Submittal Review Response

Project Name: Hilo WWTP Rehabilitation and Replacement Project Phase 1
Submittal No.: 03200-003.0
Date: 9/25/2025

Client: County of Hawai'i **Carollo Project No.:** 203975
Contractor: Nan, Inc.
Submittal Name: Concrete Reinforcing Screening Wall and Top Slab
Reviewed By: Marissa Kurniawan, Hipom Caleb Che

1'-0" THK
ELEVATION
SCALE - 1/4"=1'-0"
REF:02-S-01-103, 49/02-S-01-510

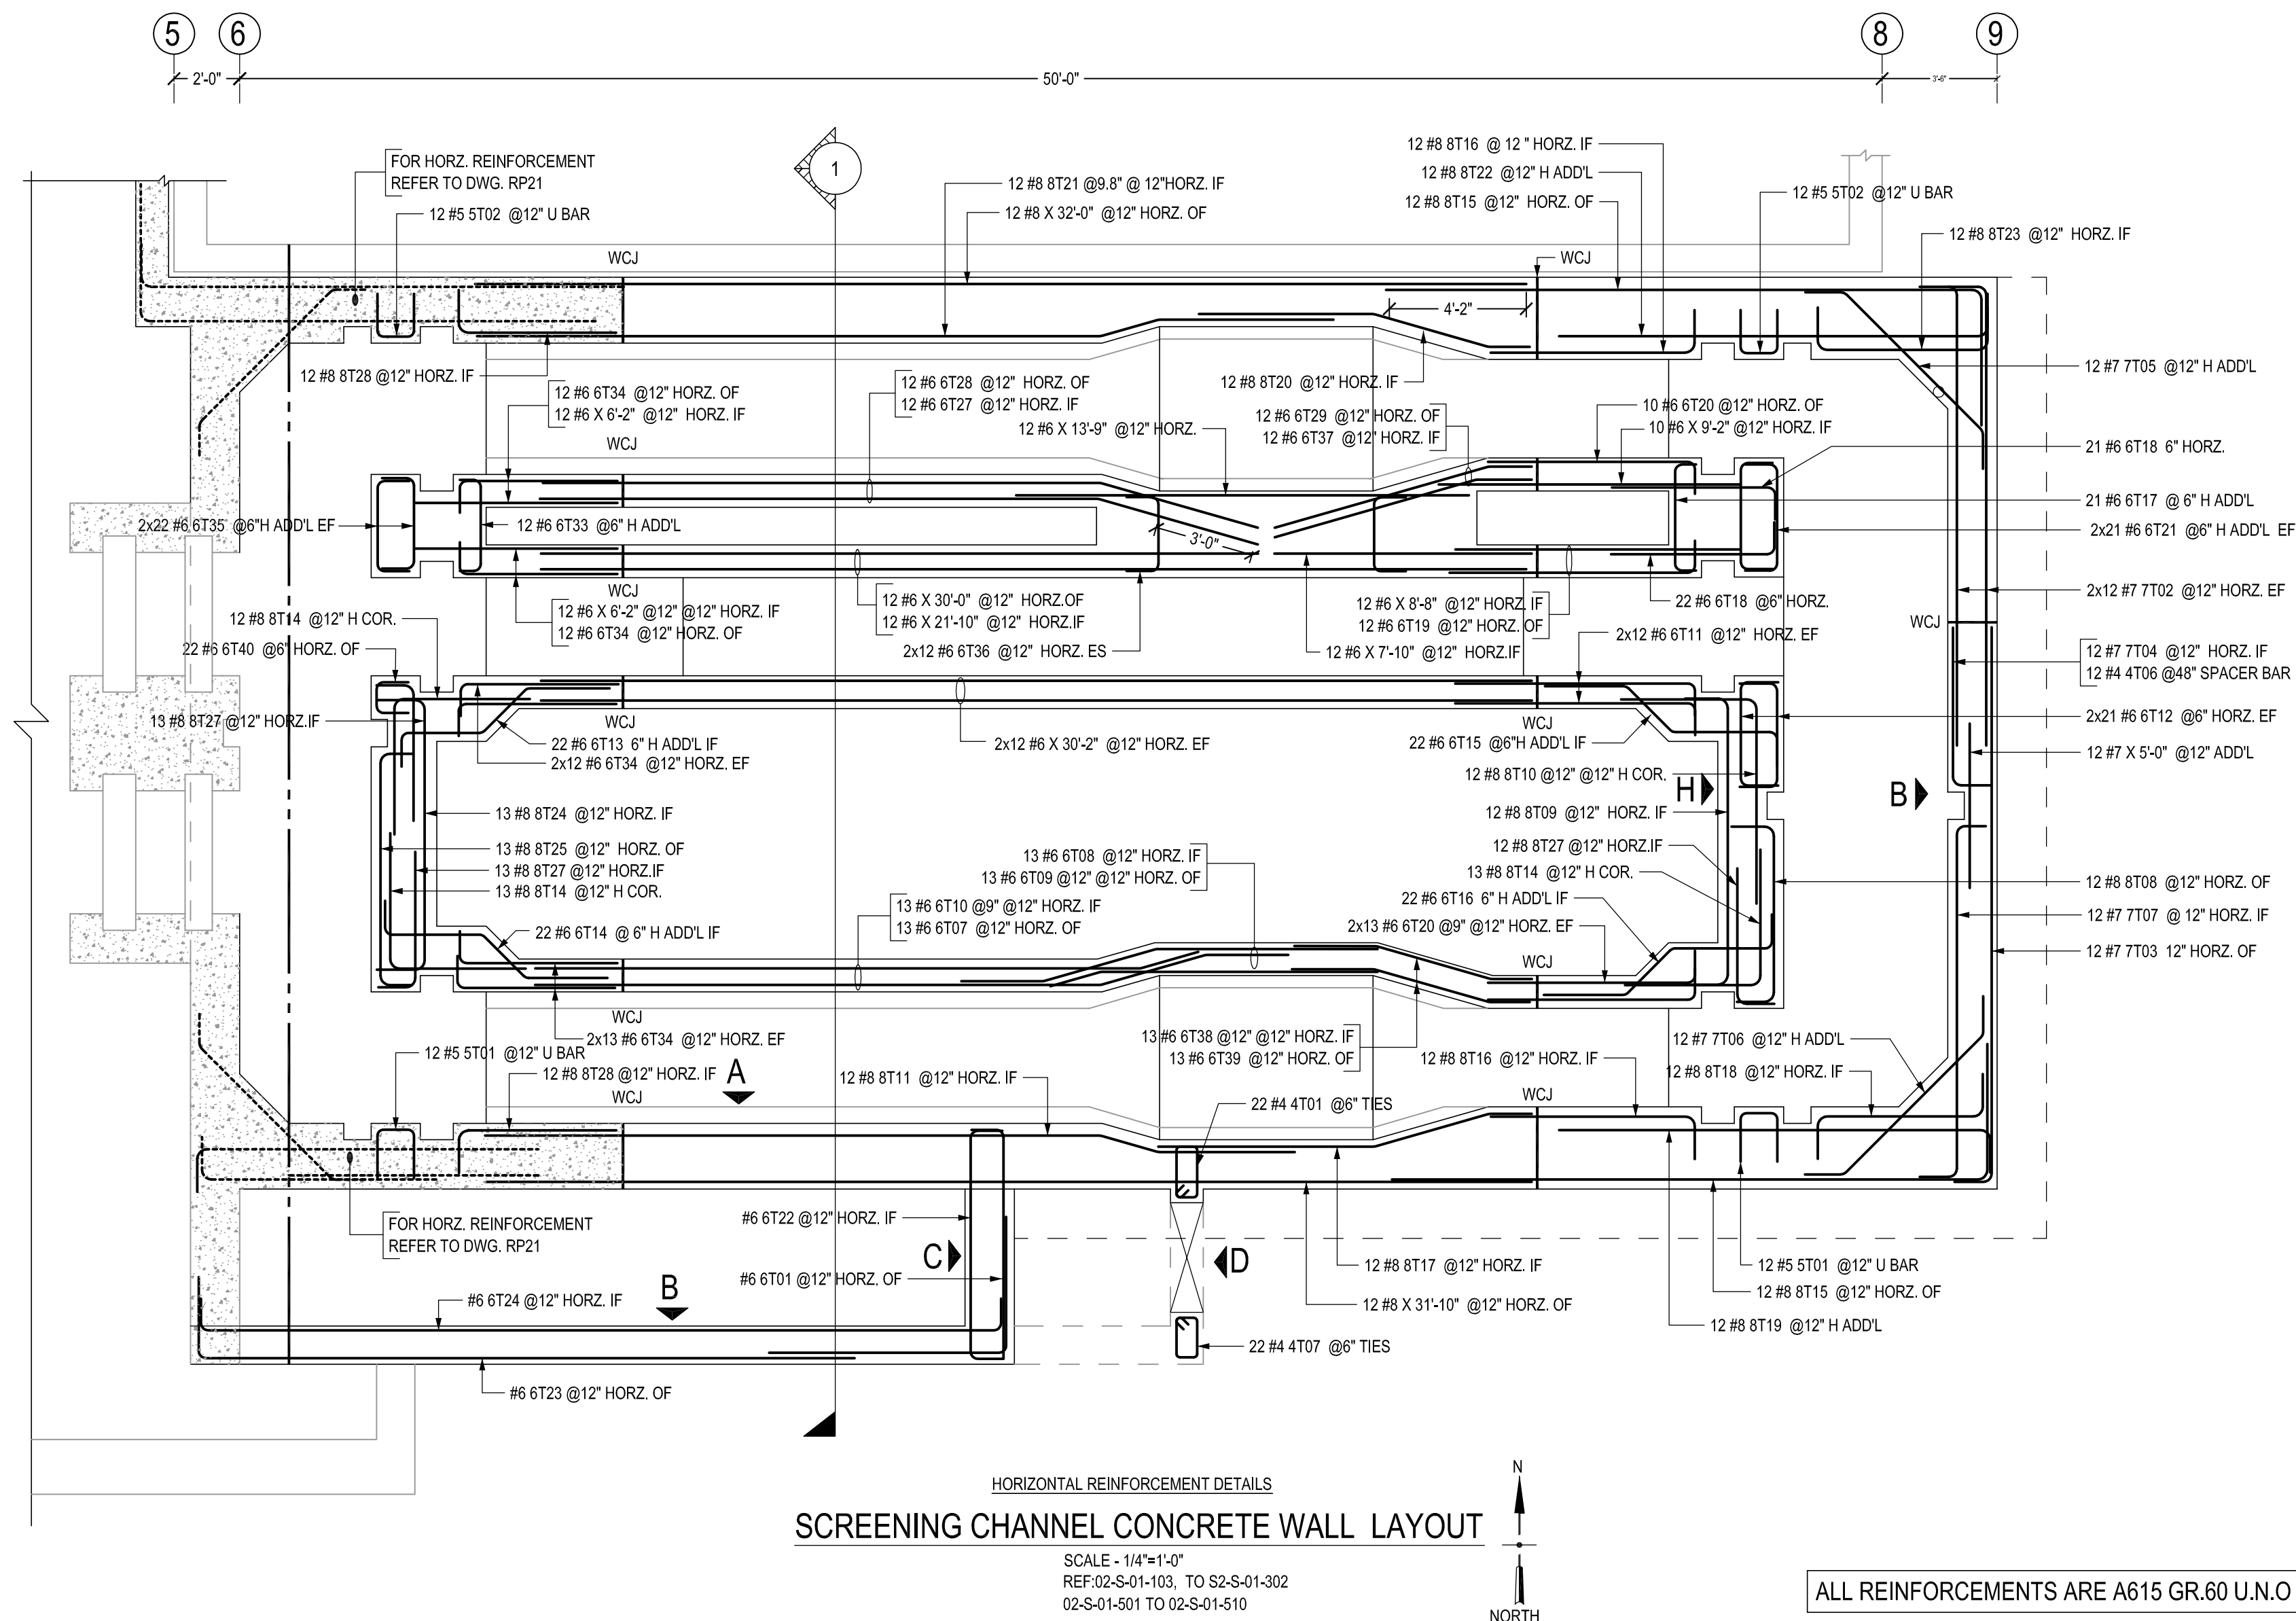
- For submittal page 1, coordinate and provide reinforcement at walls and channels for pipe openings/penetrations per P304/TYP, S180/TYP, and mechanical drawings.

- Submittal page 1 does not show wall-to-bottom slab joint profiles around drain pipes. At interfaces between wall-to-bottom slab around drain pipes on contract drawing 02-S-01-103 (indicated by key note 17 and 18), provide reinforcement per detail 60/02-S-01-512. Additionally, at corresponding locations on the bottom slab, confirm that reinforcement per S158/TYP is provided.
